Since this drainage report is the same as that submitted for Filing No. 1, my comments are the same.

FINAL DRAINAGE PLAN

THE RIDGE AT LORSON RANCH

FILING NO. 1: SF 22-XX ← SF224

NOTE:
AFTER CONCRETE STRUCTURE HAS BEEN POURED
ALL GRATE DIMENSIONS SHALL BE FIELD VERIFIED
PRIOR TO GRATE CONSTRUCTION

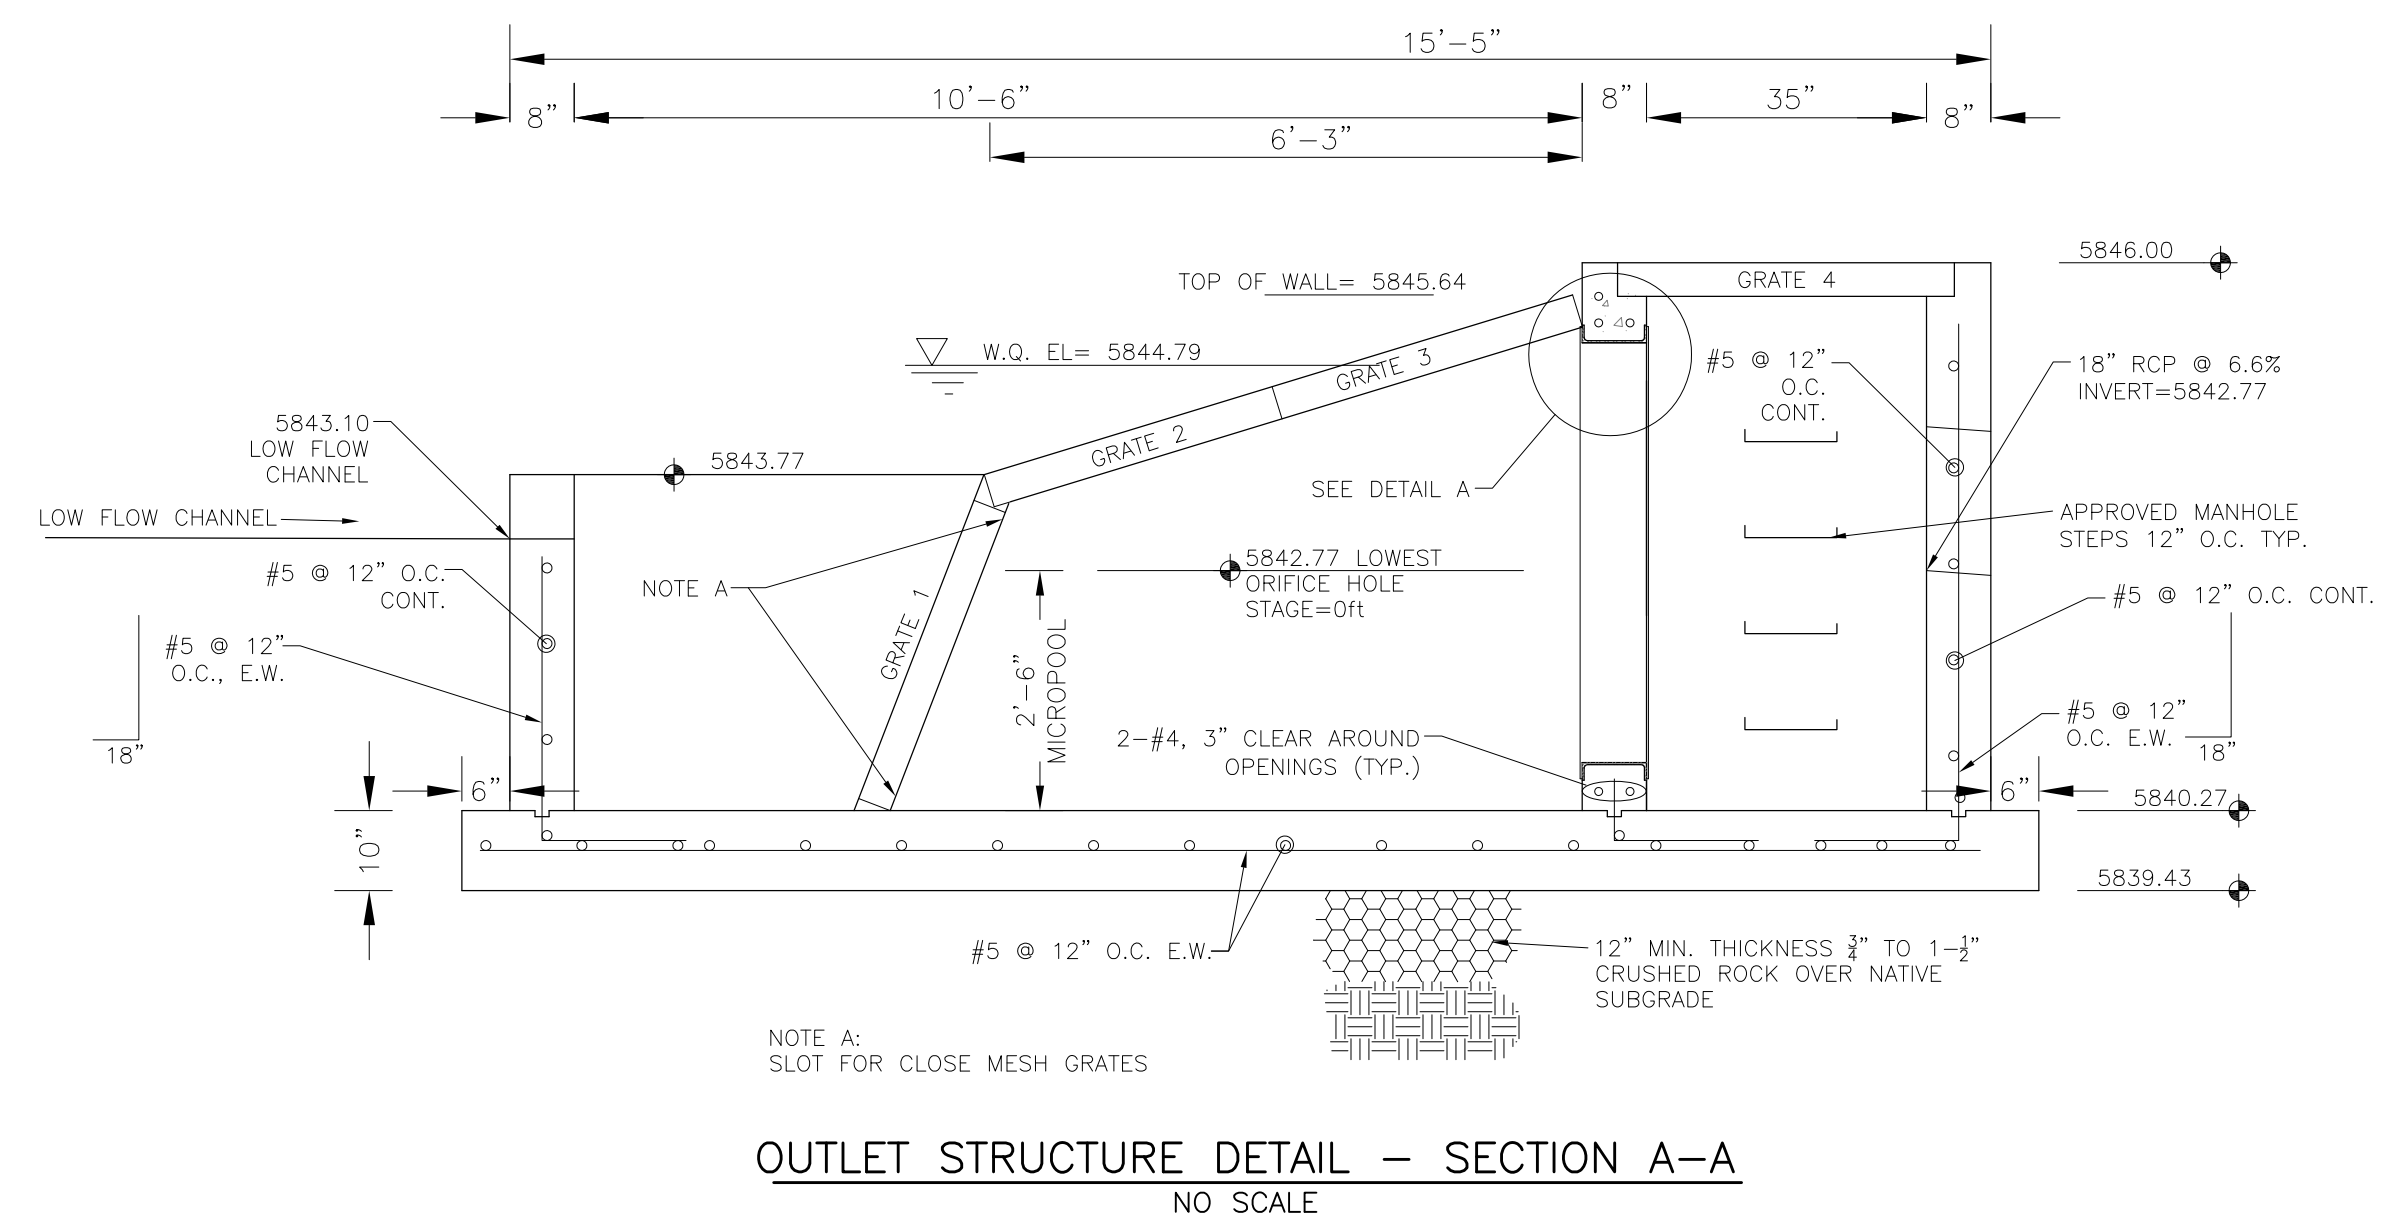
Pg 190 above shows that this should be 72"

MHFD Detail T-12 shows a 3" min between micropool WSEL and the outlet pipe invert.

Consider potential maintenance difficulties with this outlet structure configuration. How will debris and sediment be removed from these two chambers since there is so much volume below the outlet pipe invert?

**EXISTING CONDITIONS
 PUD / PRELIMINARY PLAN
 THE RIDGE AT LORSON RANCH**

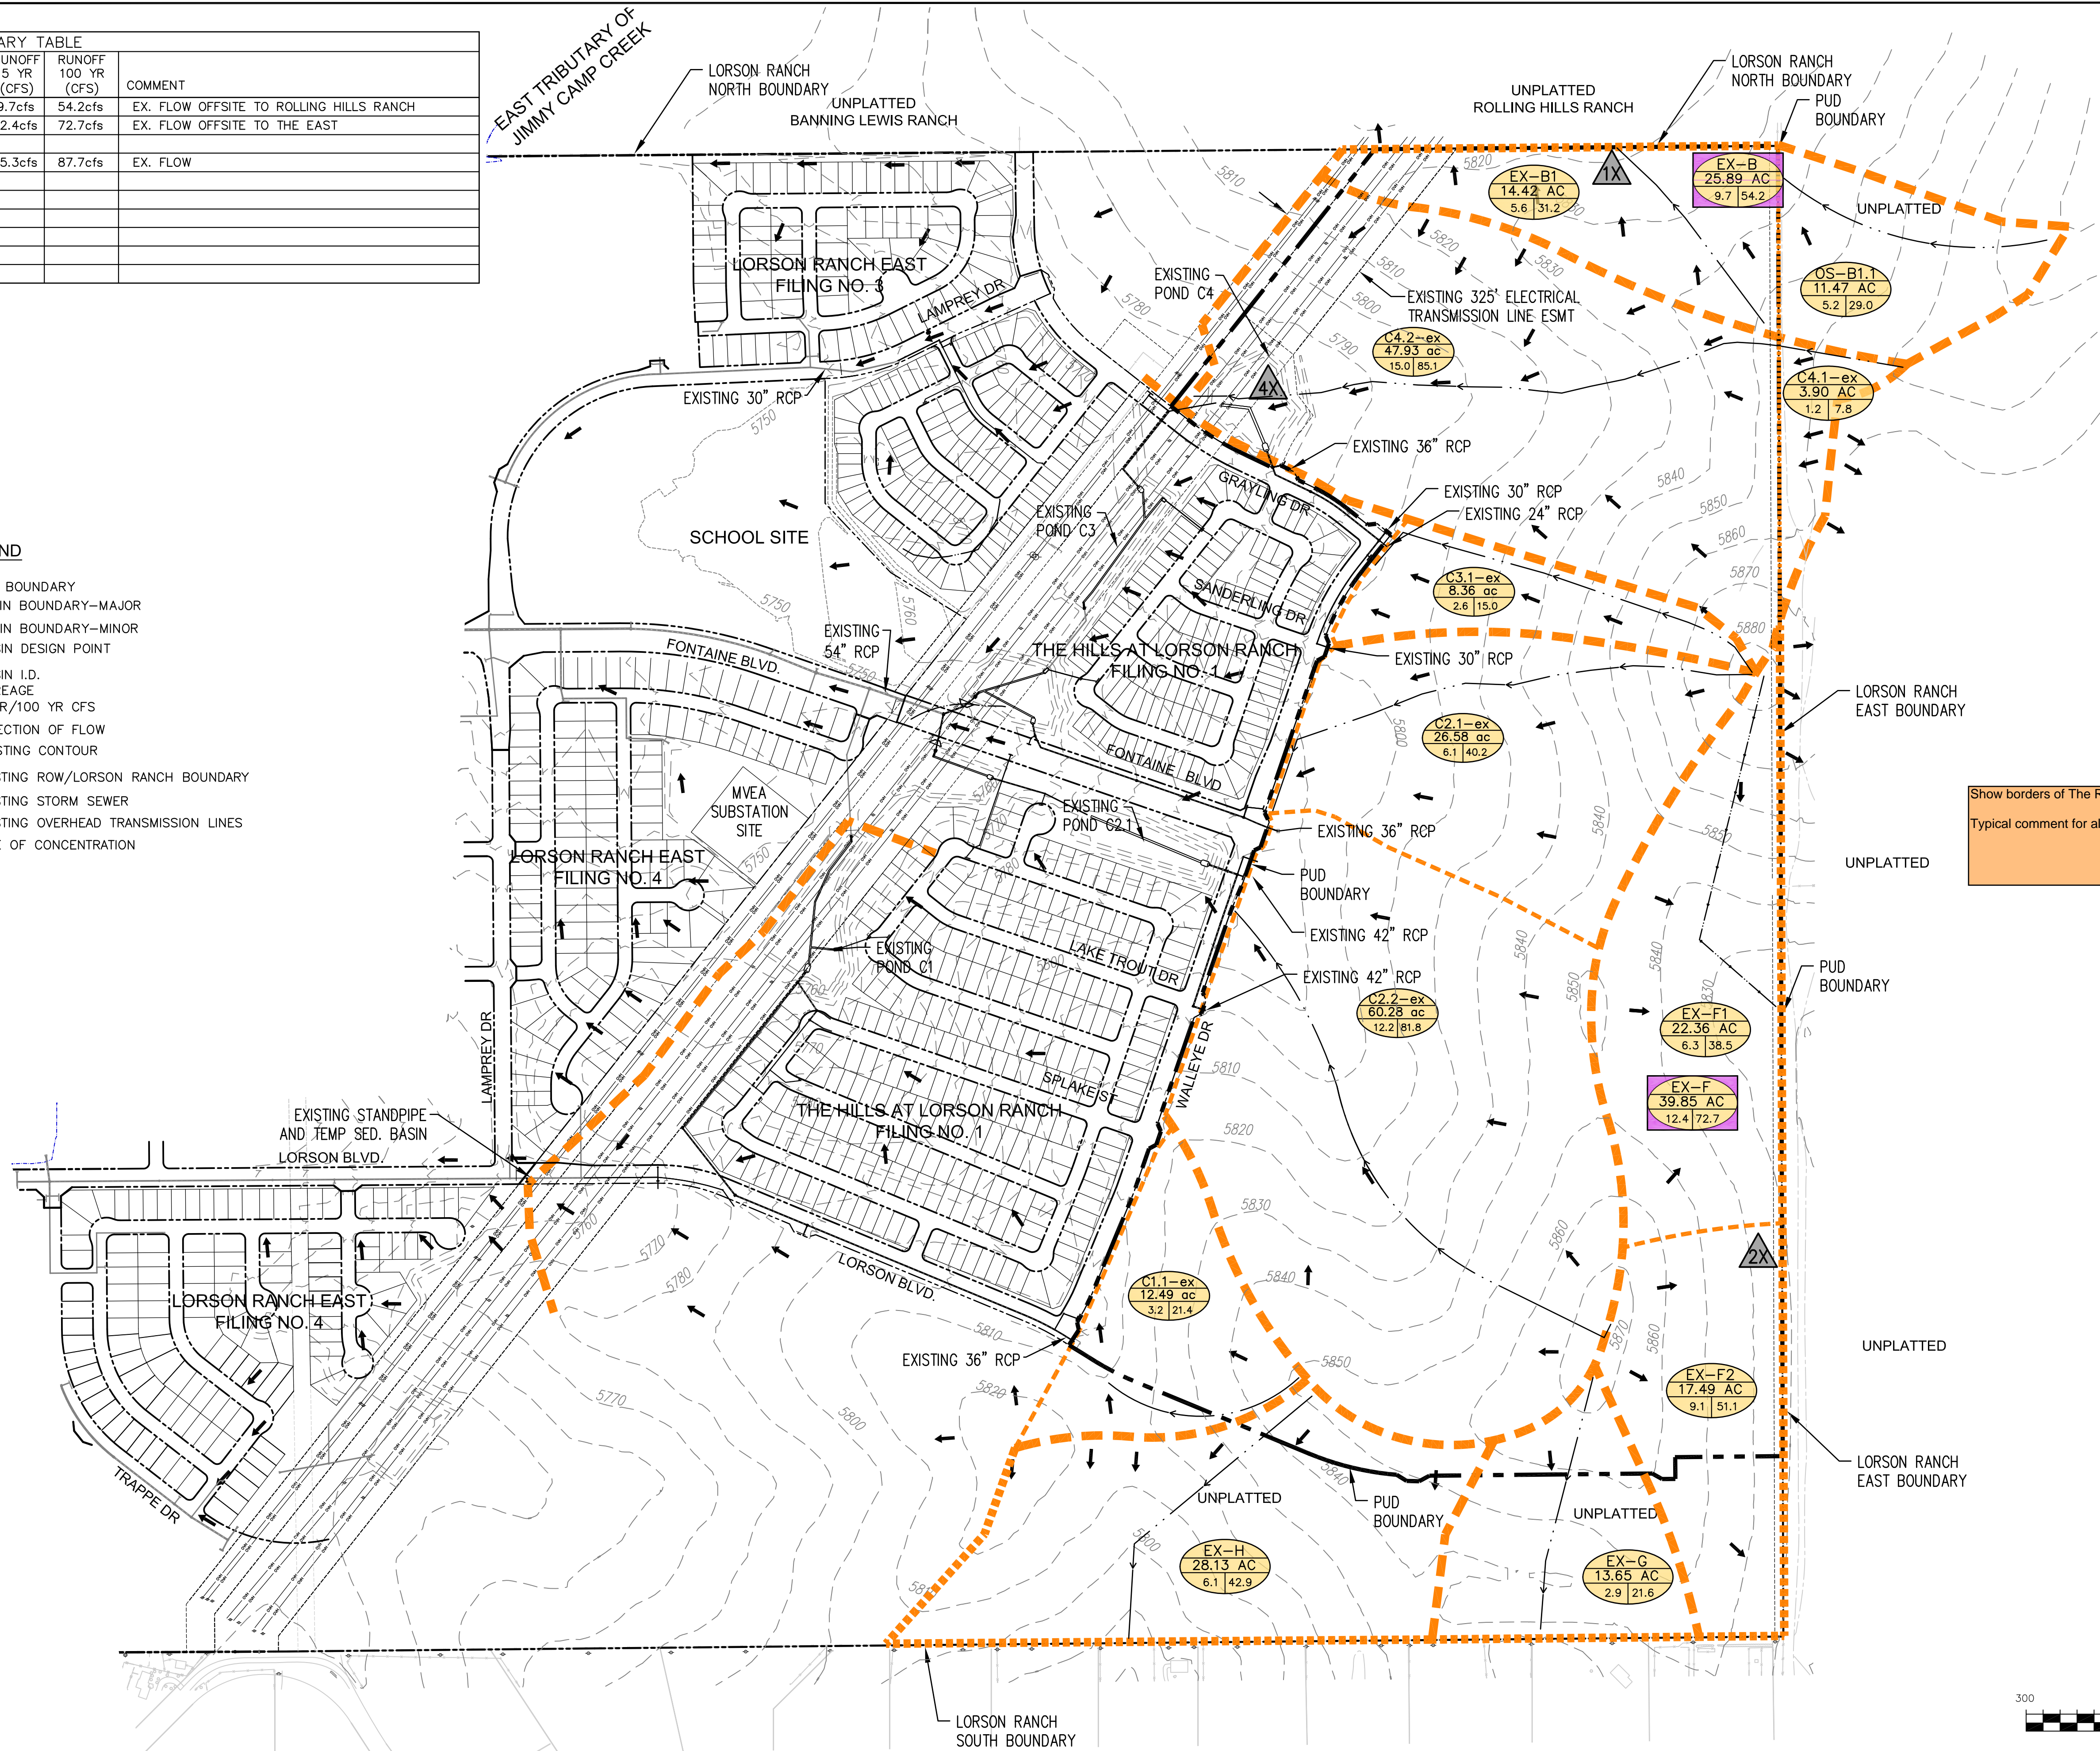
Show borders of The Ridge Filings 1, 2, and 3.
Typical comment for all subsequent maps.
